APPEAL SUMMARY

Status: Decision Rendered - Reconsideration of ID 27601

Appeal ID: 27668	Project Address: 1735 E Burnside
Hearing Date: 4/13/22	Appellant Name: Thomas Ellicott
Case No.: B-008	Appellant Phone: 5035488674
Appeal Type: Building	Plans Examiner/Inspector: Catherine Heeb
Project Type: commercial	Stories: 3 Occupancy: A-2 Construction Type: V-B
Building/Business Name: Gold Record Hi-Fi Bar	Fire Sprinklers: Yes - full building
Appeal Involves: Alteration of an existing structure, Addition to an existing structure, Reconsideration of appeal, occ Change from Mixed B-R2 to A2	
LUR or Permit Application No.: LU# 21058141 DZ	
Plan Submitted Option: pdf [File 1] [File 2] [File 3] [File 4] [File 5] [File 6] [File 7] Proposed use: Nightclub

PROJECT NAME:
GOLD RECORD Hi-Fi BAR
1735 EAST BURNSIDE
CORNER OF: E. BURNSIDE AND SE 18TH AVE.

A2.7

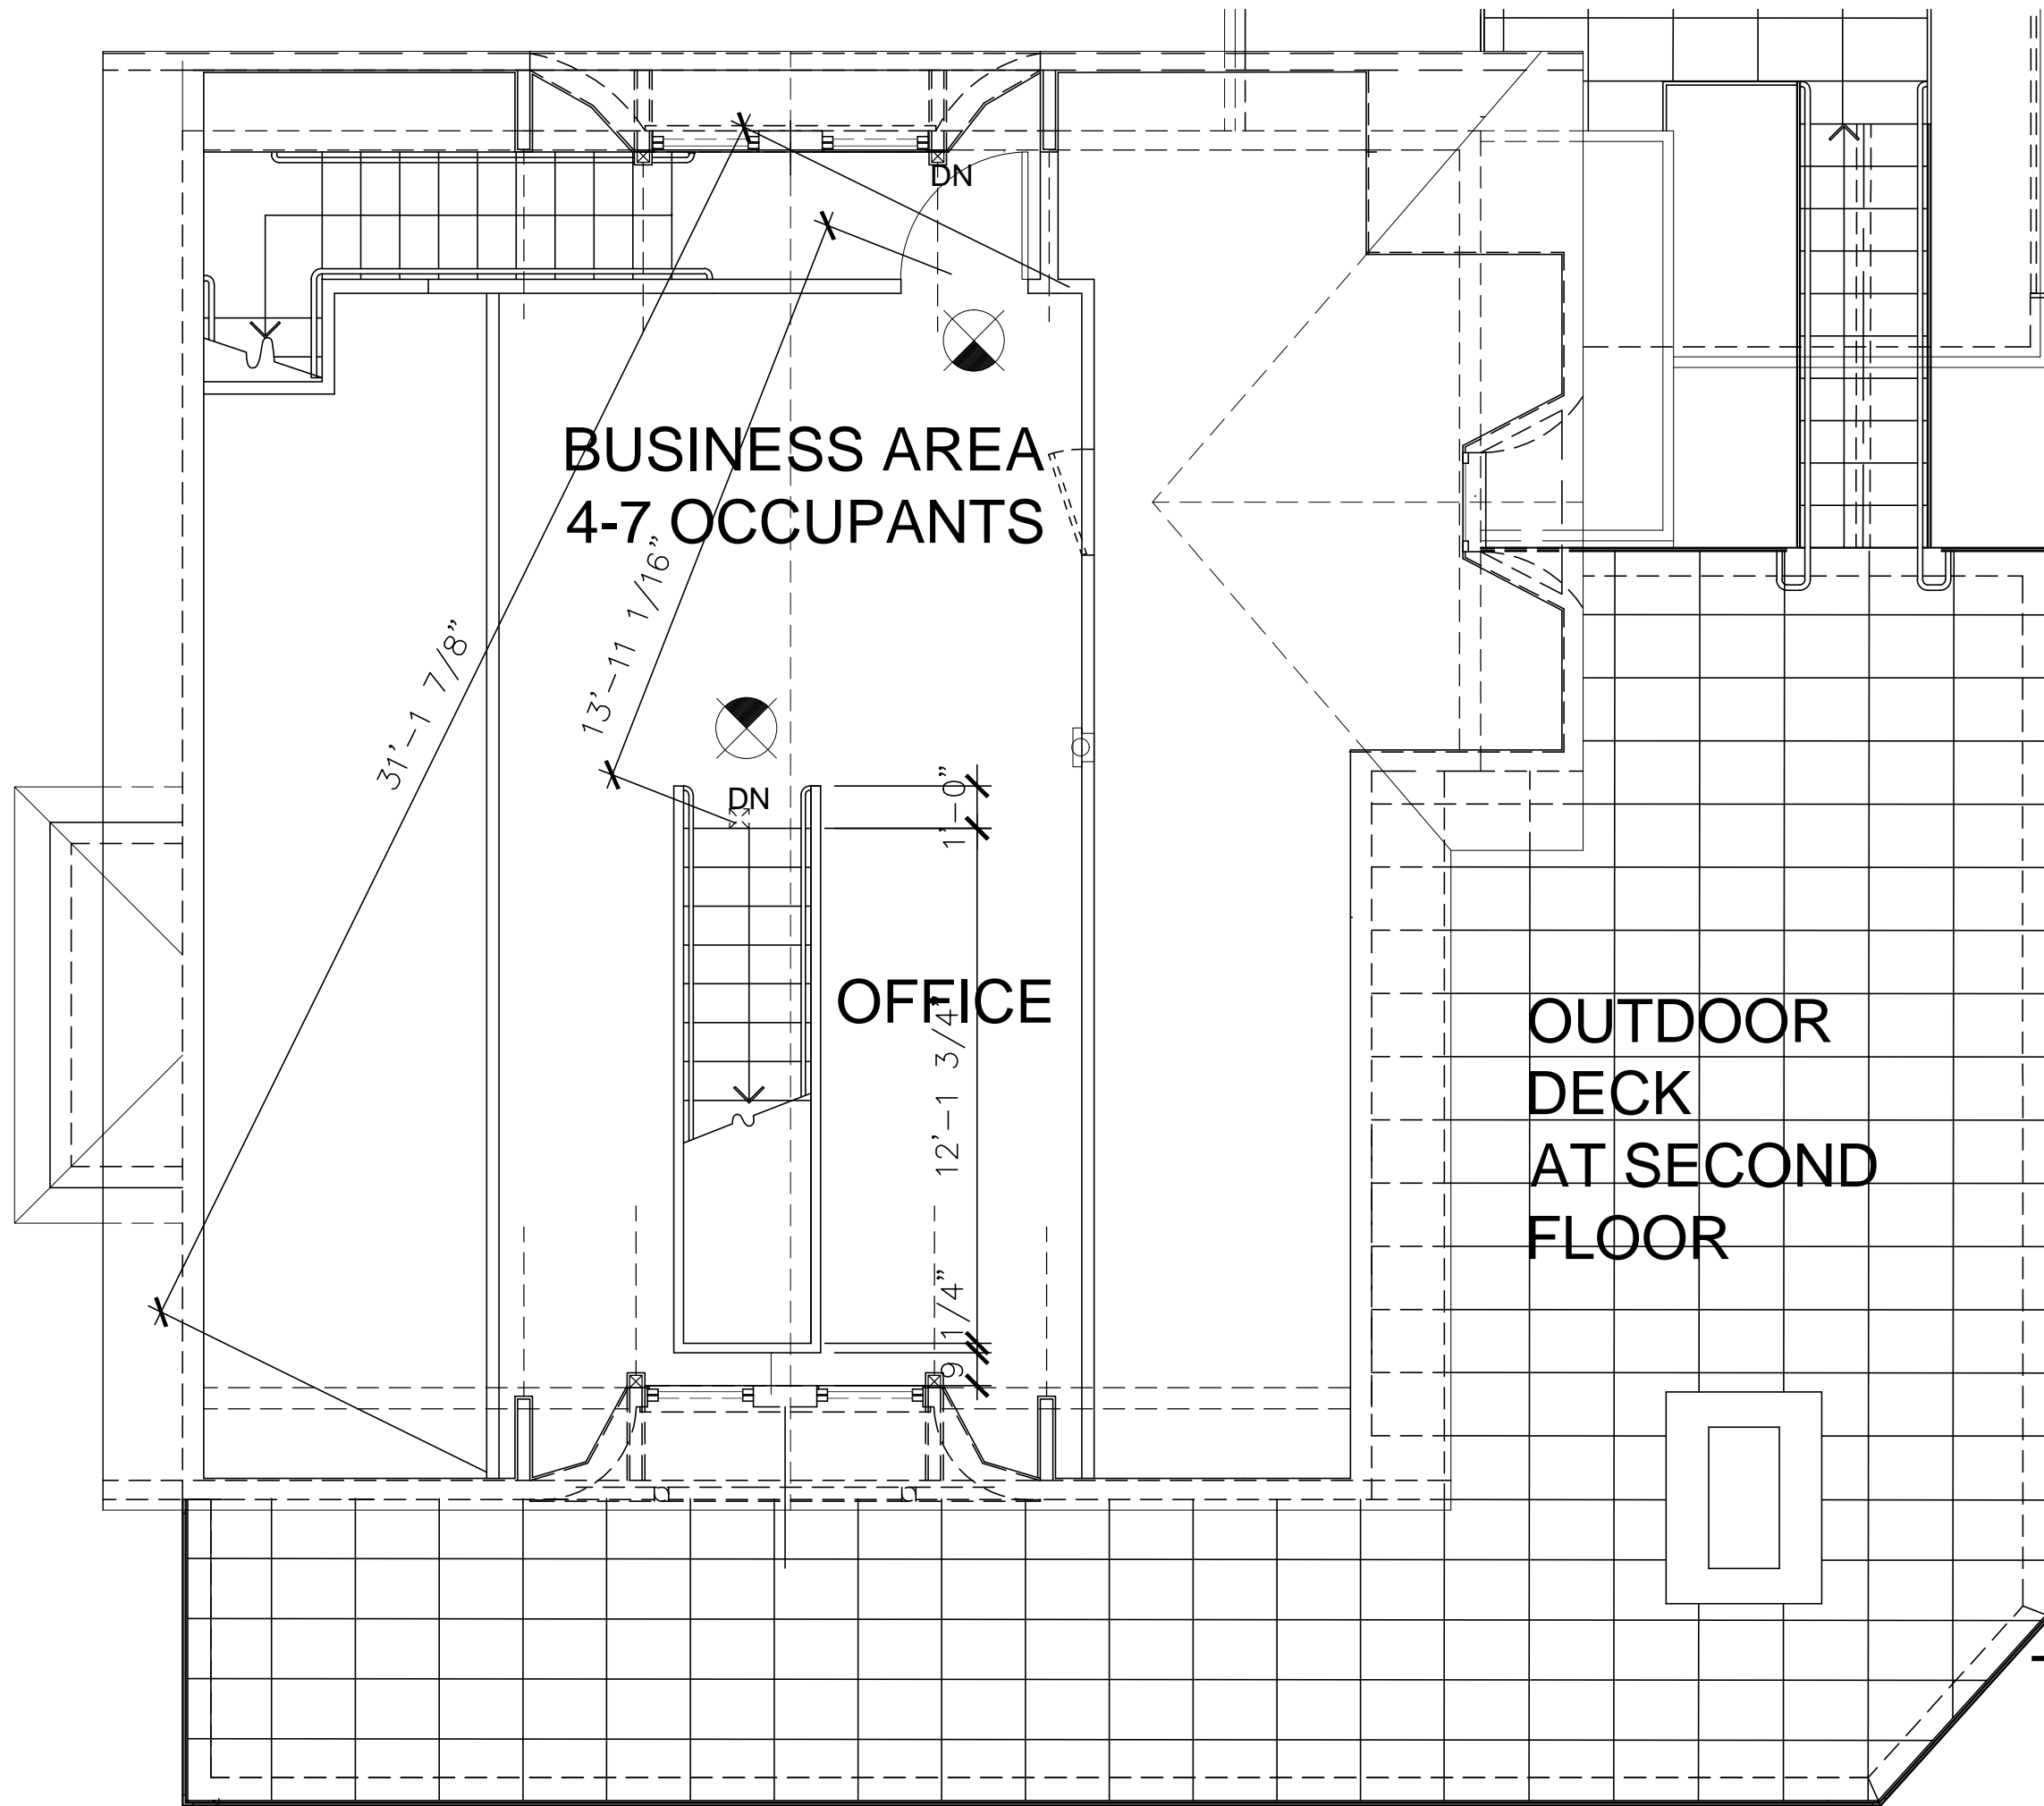
Code Section	Table 1006.3.3(2)
Requires	Stories with one exit or access to on exit for other occupants, third story above grade plane NP (Not Permitted)
Code Modification or Alternate Requested	The intent of the appeal is to comply with the above table by changing the design to provide a second exit stair from the third floor to exit to the second floor.
Proposed Design	<p>The existing stair will be replaced with a 3-foot-wide stair, using select structural lumber designed to carry 100 lbs per square foot. The stair is built to code at a minimum 6'-8" head clearance with 7" risers, 11" treads and handrails each side with code required returns. Separation from the second floor will be 1hr construction, wood framing 16"o.c. and 5/8" type X gypsum board each face and closed off from the second floor with a B-label 20-minute door using conventional hardware of accessible quality.</p> <p>"Reconsideration Text": Two exits are provided from the third floor, both of a required 3-ft width and both stair shafts rated at 1-hr. separation from the second floor. Both stairs will be code compliant with handrails, headroom clearances, riser and treads. Please see attached drawings A2.8 and A2.7.</p>

Code Modification or Alternate Requested	The submitted design is providing a rated interior stair shaft and exit passageway from the second floor directly to the exterior of the building.
---	--

Proposed Design	<p>The interior stair from the second floor to the first floor has installed materials making it 1-hr. rated required by table 508.4. A 13 foot exit passageway is needed for the stair to exit the building. All doors into the stair and passage way are rated 1-hr and have door closers. Magnetic hold opens are installed on the 2nd floor and first floor doors with panic hardware on the access side of the door latch.</p> <p>The 3rd floor office space creates a mixed occupancy building. The 3rd floor stairs do not connect to the interior stair shaft, half the 3rd floor people can enter the 2nd floor interior stair shaft. Section 711 should not apply to this passageway, however out side the building from this exit is a 9-foot open air passage to the public way sidewalk. If required we will install 2 hr. walls both sides of this passage.</p> <p>The corner window in the passageway wall receives two layers of 5/8" type X gypsum board with black out mineral wool insulation to close off the interior wall. The toilet rooms accessed through the passageway and are not considered normal occupied space. However, in a nightclub they will be frequently occupied. Horn strobes with smoke detection provides early warning. The toilet rooms exhaust goes to the north exterior wall, no penetrations pass through the stair or passageway. Emergency lighting is provided in stair and passageway.</p>

2. Exiting from 2nd floor: Denied. Proposal does not provide equivalent Life Safety protection.

A2.8

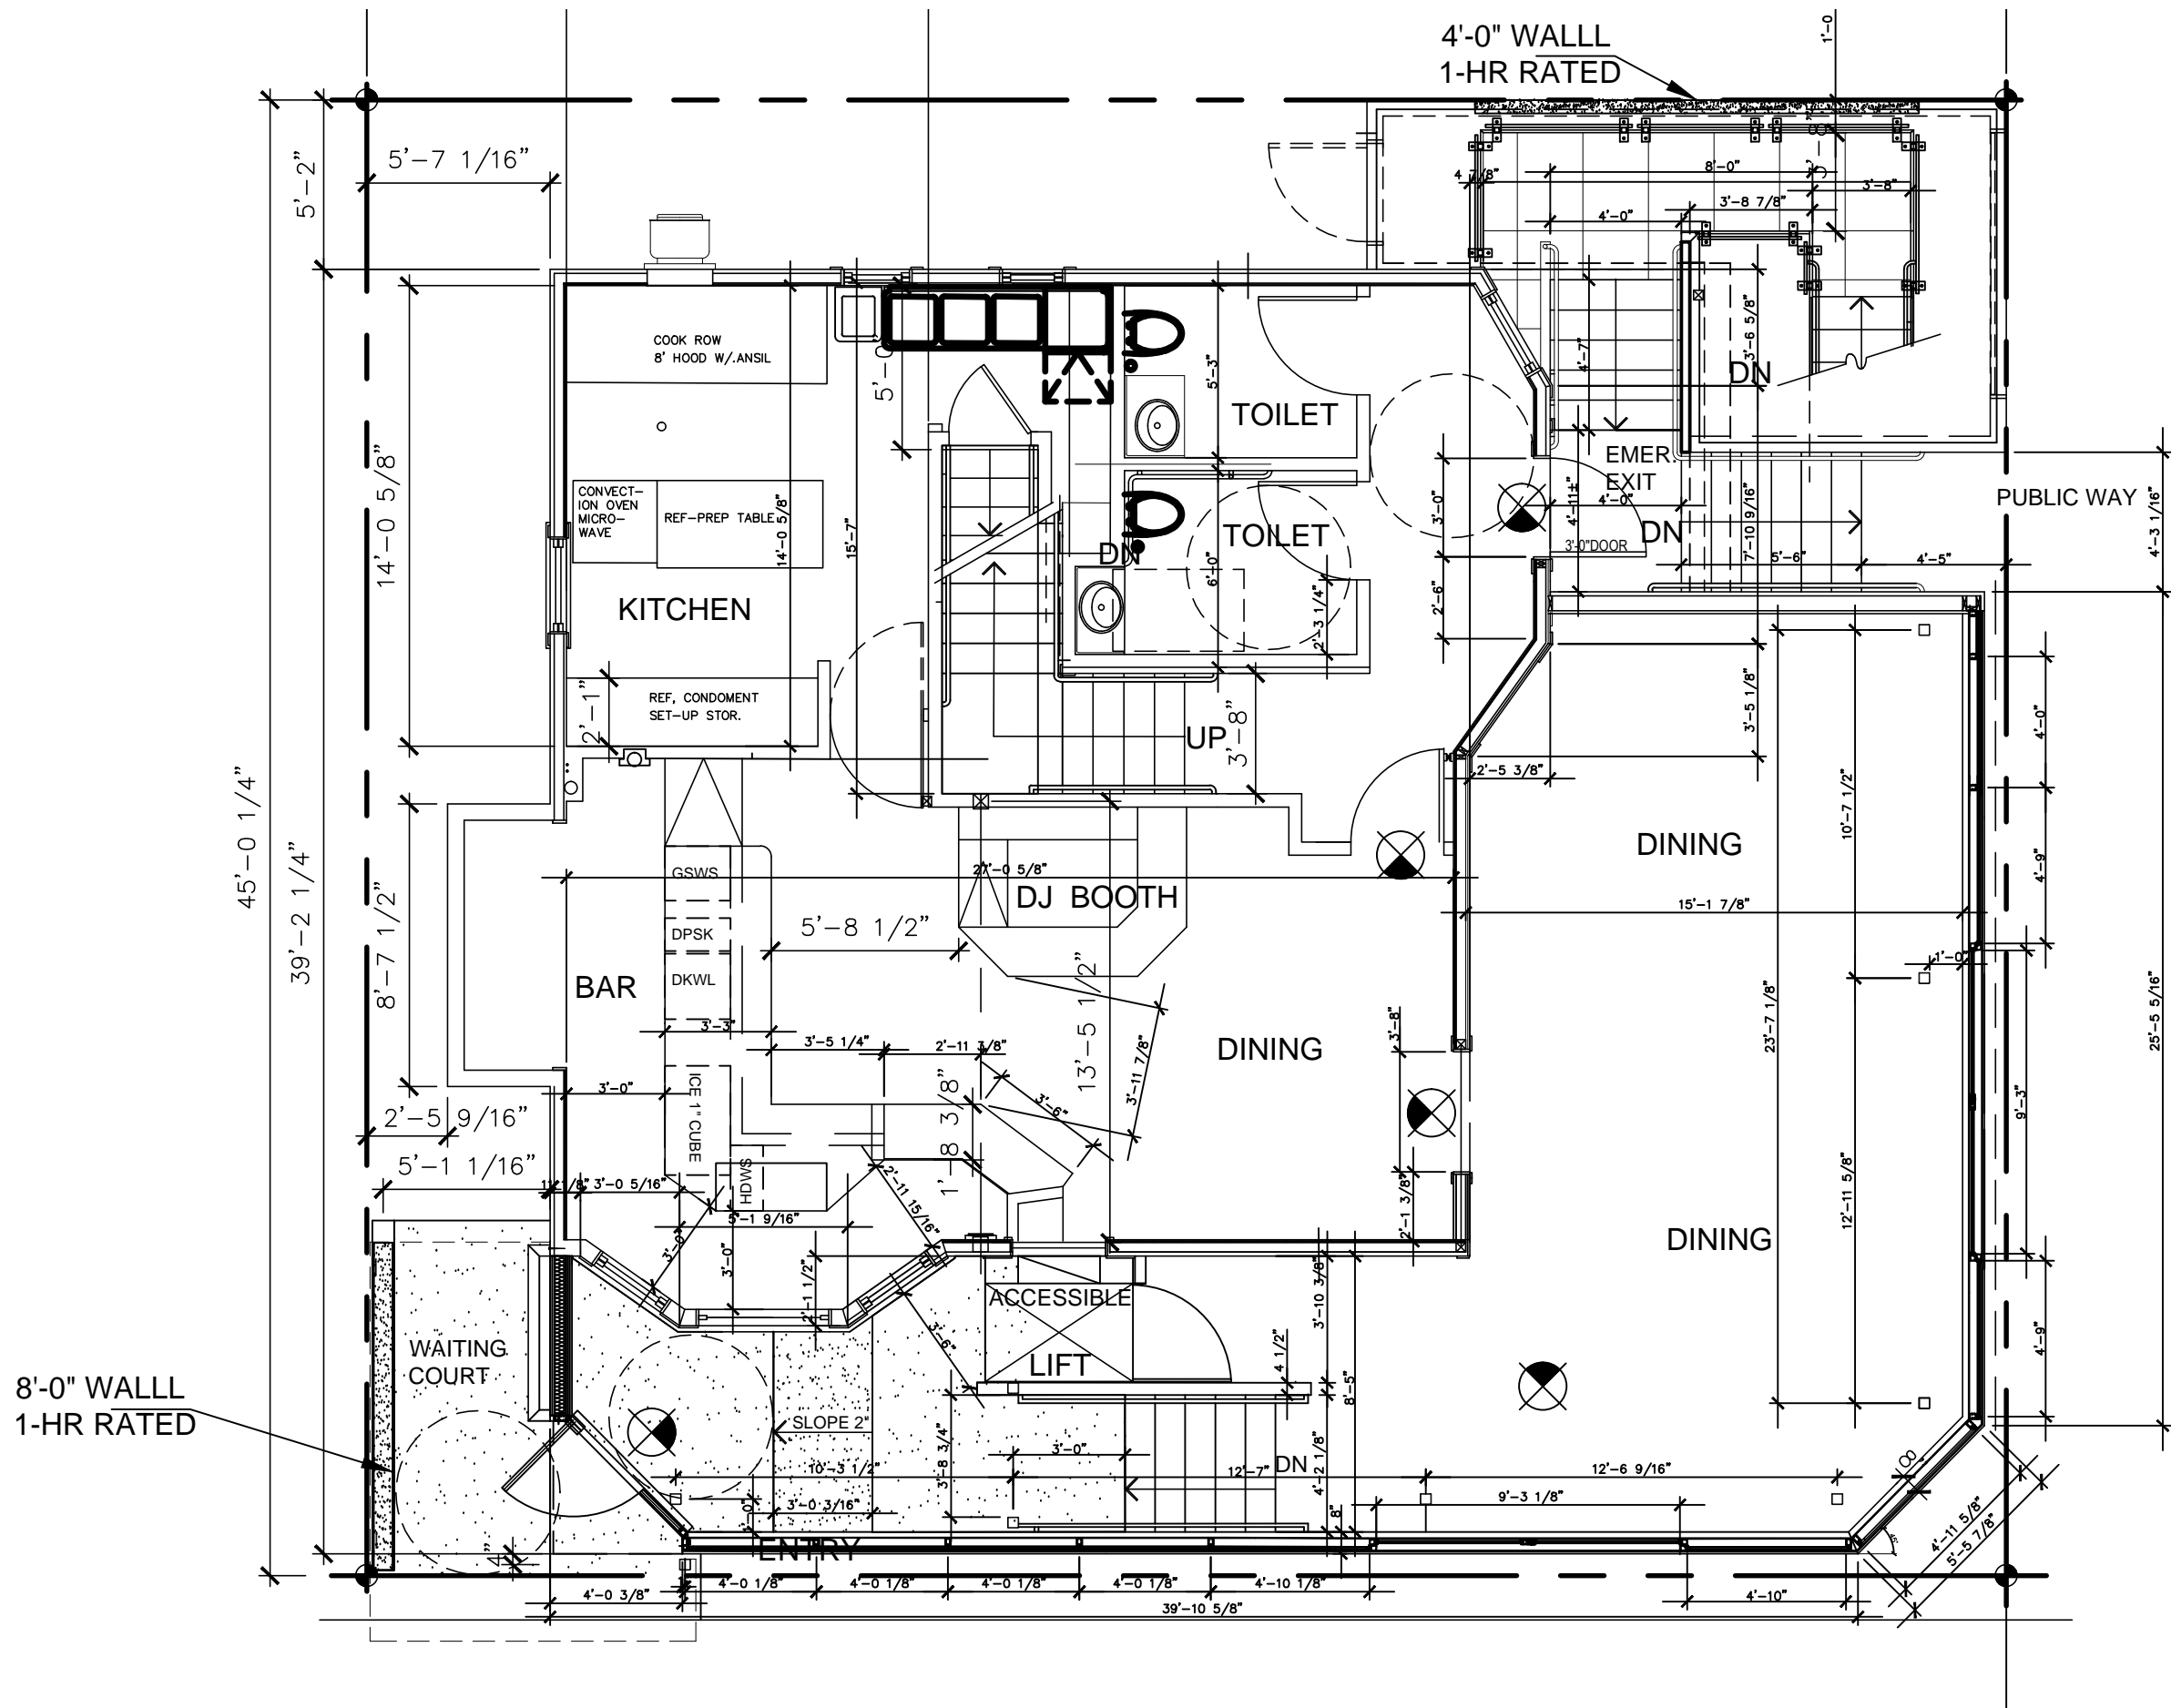
"Reconsideration Text": A second exit from a third floor is required to meet safe exiting requirements and is show in the attached drawing. The project is redesigned to meet building codes by compliance with table 1006.3.3(2).

1. Use of two exit access stairs to provide egress from 3rd floor to 2nd floor: Granted as proposed.
